**COASTAL DEVELOPMENT PERMIT APPEAL:
SUBSTANTIAL ISSUE DETERMINATION AND DE NOVO HEARING**

Application numberA-3-SLO-00-118, KK Ranch

Project location.....7292 Exotic Gardens Drive, Cambria, San Luis Obispo County

Project description9,654 sq. ft. single family residence including an attached garage and workroom; 600 sq. ft. guesthouse with a 480 square foot garage; 2,400 sq. ft. storage barn with 600 square foot loft; 2,400 square foot horse barn; and 1.4 acre pond filled by runoff

Visual Simulations
by Applicant

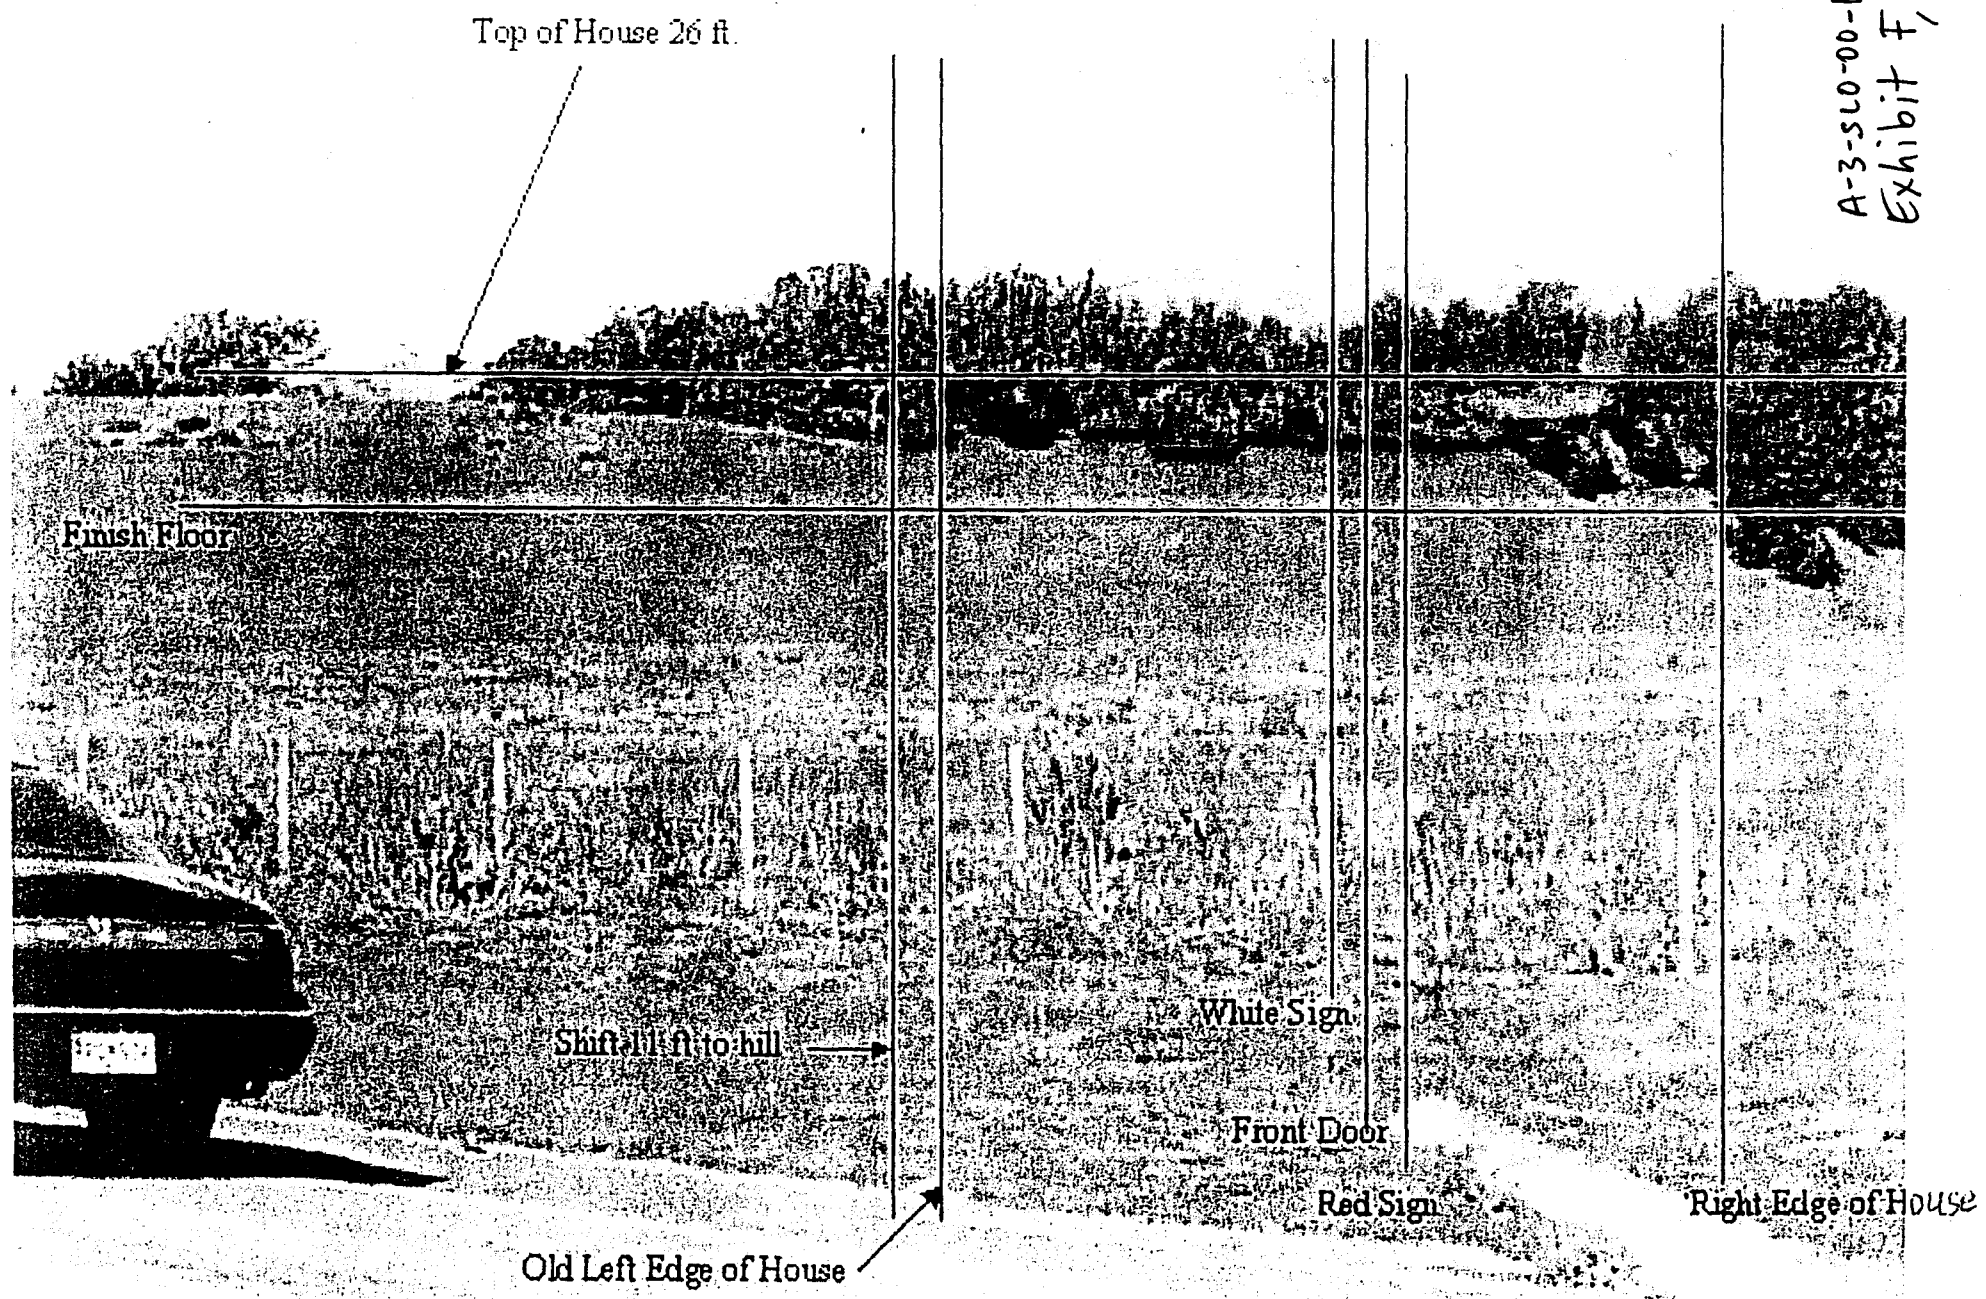
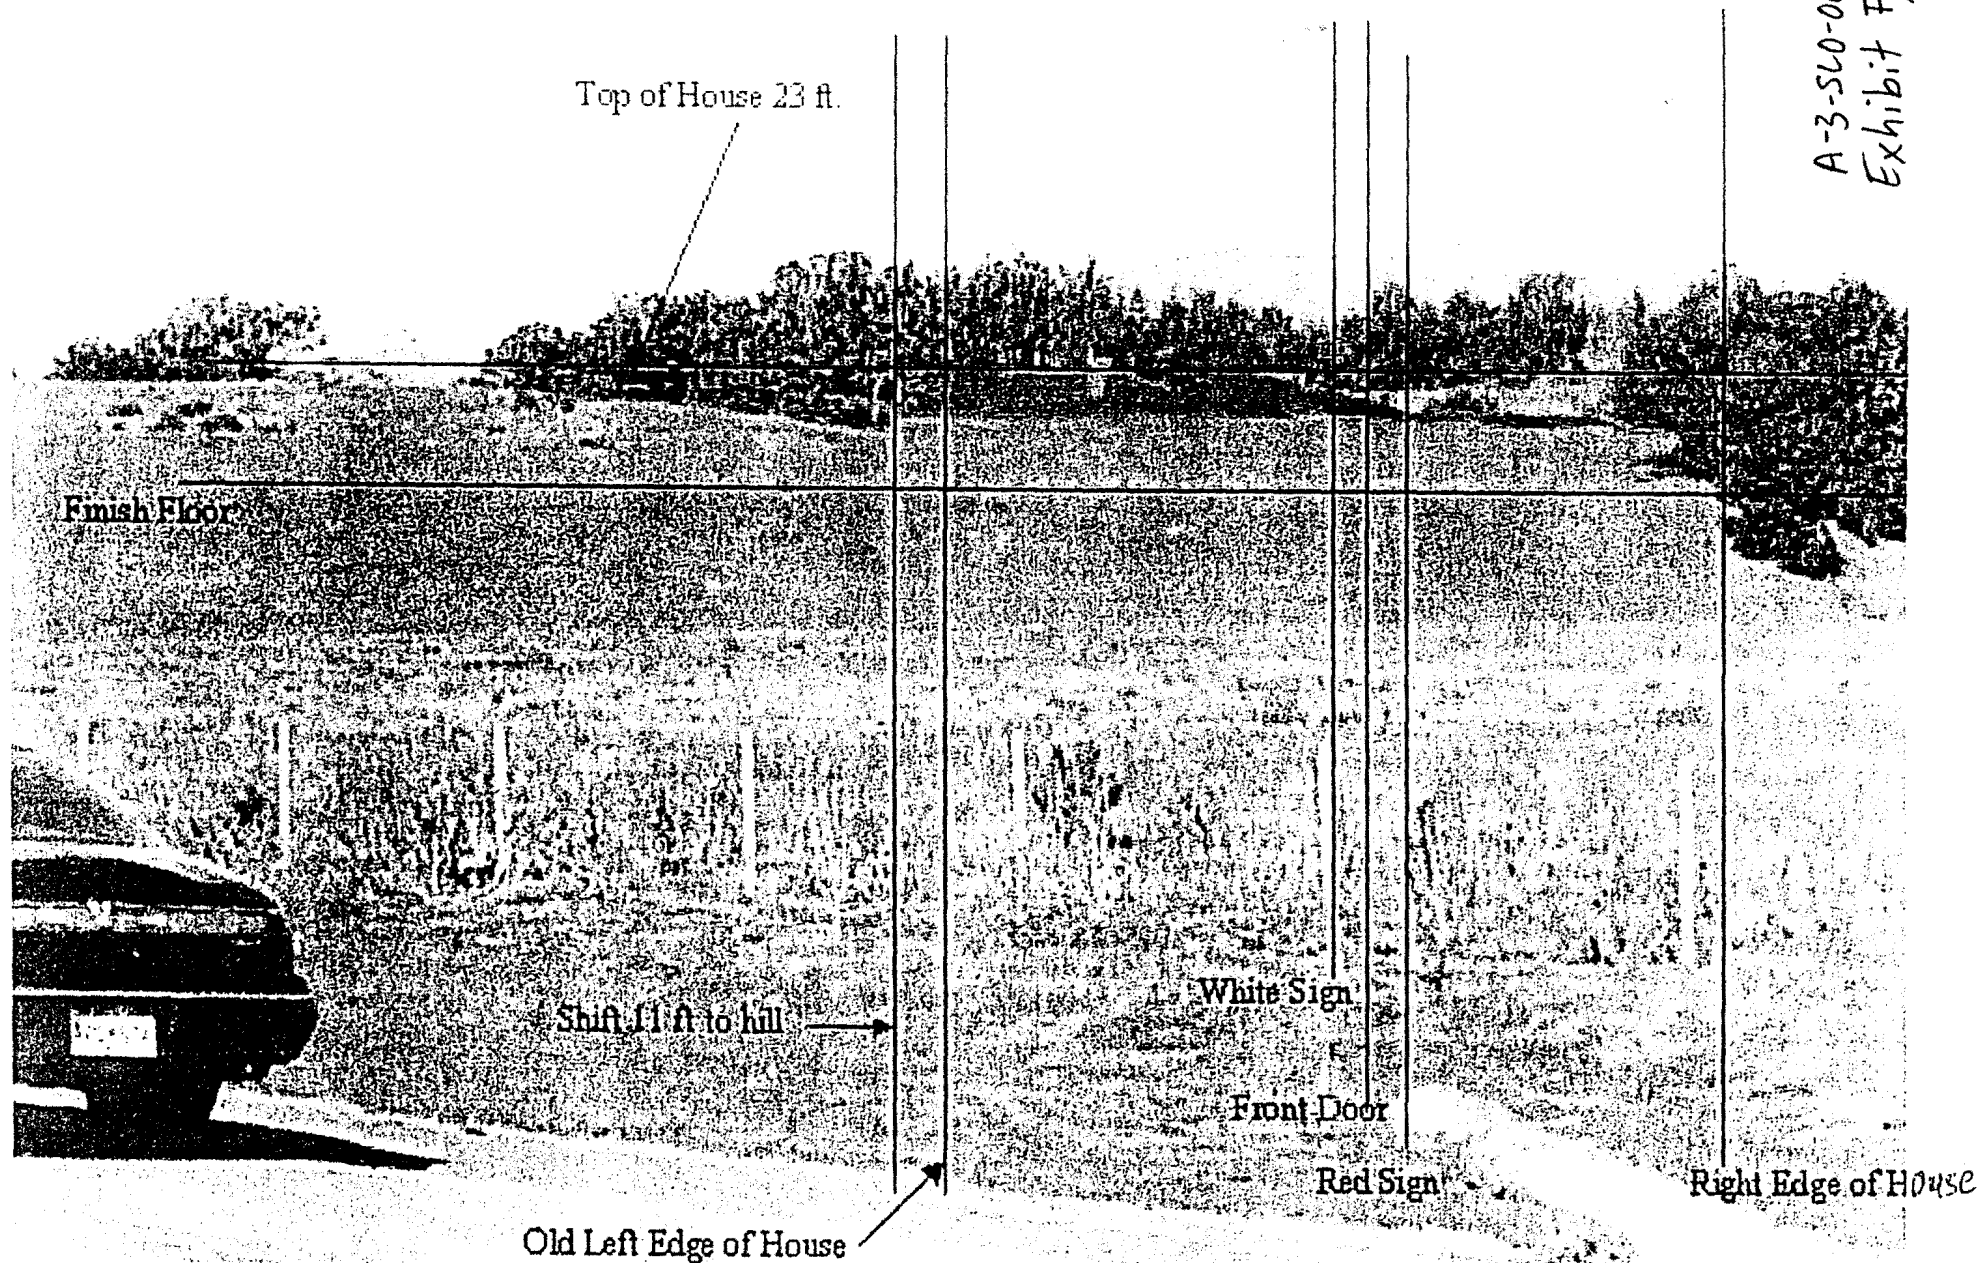
I am sending you this package to provide you with the last bit of information you required before making your final decision. As you can see from the "Visual View from both south and north of the Highway 1", the house is moved 11 ft toward the hill. Please find enclosed the two renderings; one for 23 feet and one for 26 feet, the reduction of the height from 26 feet to 23 feet produces minimal change and it can be hardly noticed, especially when the trees are grown. However, such reduction will make a big difference in the design of my house and as you know 26 feet was the height that we compromised with the county to build our house. The height limitation for normal circumstances is 35 feet and the property that was approved and built that is directly adjacent to mine has 35 feet height.

PROPOSED NEW LOCATION HOUSE SHIFTED 11 FT TO HILL & HEIGHT OF THE HOUSE REDUCED 3 FT.

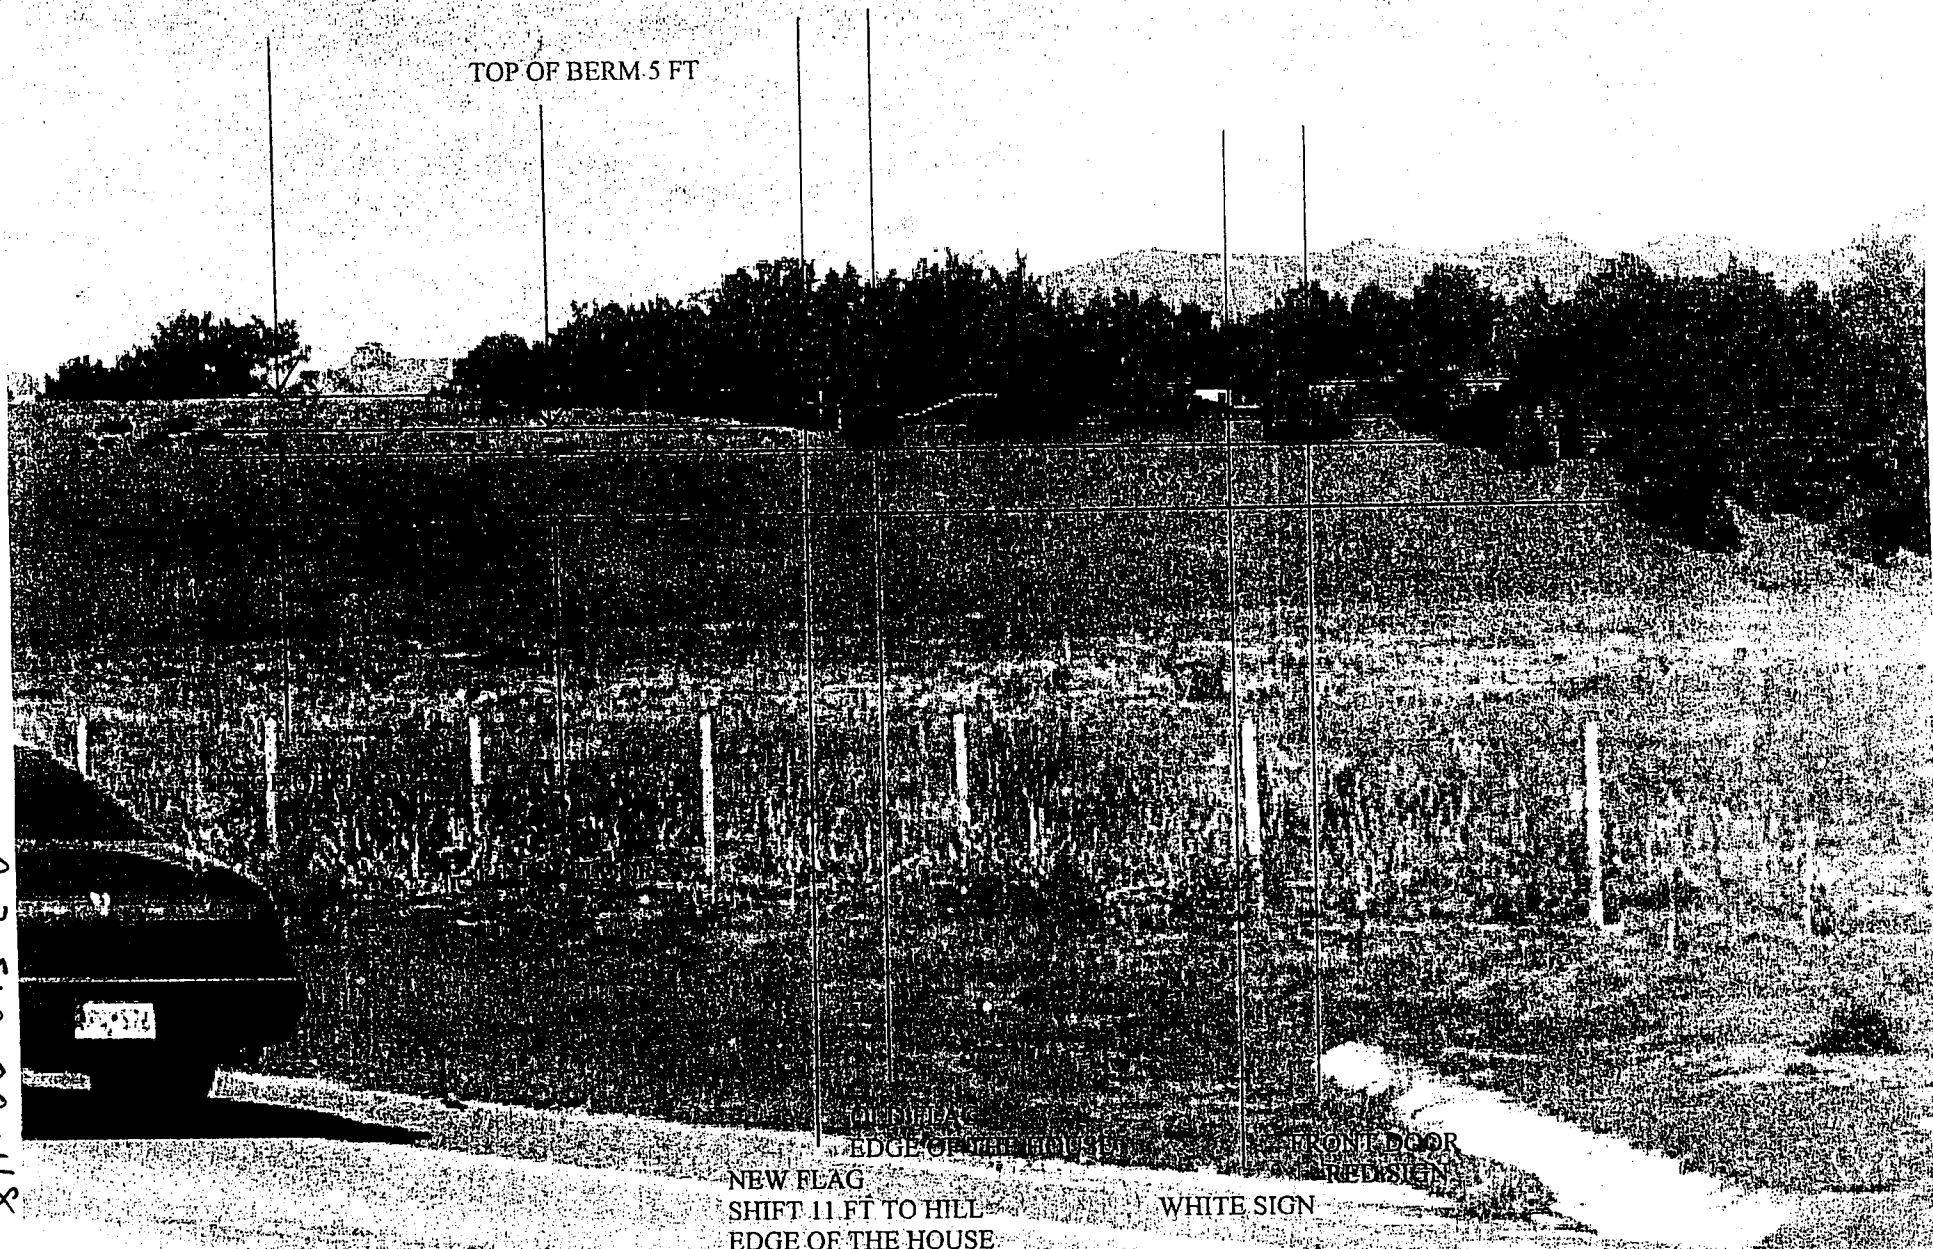
I have moved the house 11 feet closer to the hill, dropped the height of the house another 3 feet, and planted more than 100 trees that have been growing very fast and will eventually be very tall, in the areas near the berm location. Further, you can be assured that the color of the roof will not be a bright red or blue but that it will be a blend of muted colors. The colors used in the visual study is bright on purpose to emphasize the

The last thing that comes to my mind is to drop the height of my home another 2 to 3 feet which will make the house almost invisible from north and south of the highway. This will result in dropping of the height in total of about 4 to 5 feet from the original design. In addition, we have planted over 100 trees in the area north and south.

I hope that these adjustments of height, planting of the trees that will grow, and the relocation of the house will allow the lowering of the burn to 4 feet or less. The home will be hardly visible with these changes, especially as these trees grow over the years.
